# PIC18F04/05/14/15Q40

## PIC18F04/05/14/15Q40 Silicon Errata and Data Sheet Clarifications

The PIC18F04/05/14/15Q40 devices you have received conform functionally to the current device data sheet (DS40002236C), except for the anomalies described in this document.

### 1.4.1 UART TXDE Signal May go Low Before The STOP Bit Has Been Entirely Transmitted.

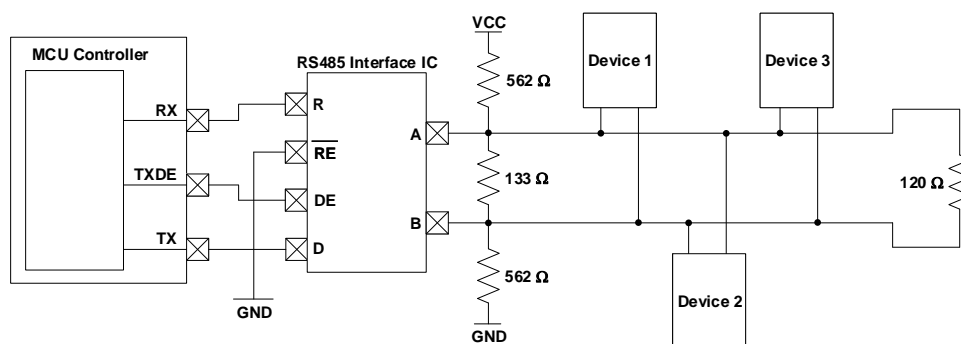
The UART Transmit Drive Enable (TXDE) signal could potentially transition into a low state before the UART STOP bit has been entirely transmitted due to the effects of parasitic capacitance on the TX line. In some applications, this could result in communication being prematurely terminated due to the TXDE bit going low before the STOP bit has had enough time to settle.

In order to ensure that the STOP bit settles into its final logic state before the TXDE signal transitions low, a biasing circuit can be implemented. A biasing circuit allows the TX line to either be driven high or low, rather than being left in a floating tri-state mode where prolonged rise or fall times could lead to communication being disrupted. This bias circuit should only be implemented on one end of the serial bus, and a termination resistor should be used on the other end. The figure below show an example of a bias circuit that can be used to achieve this.

Please note that the resistor values used in this circuit are recommendations, and that the actual resistor values required may vary based on the application.
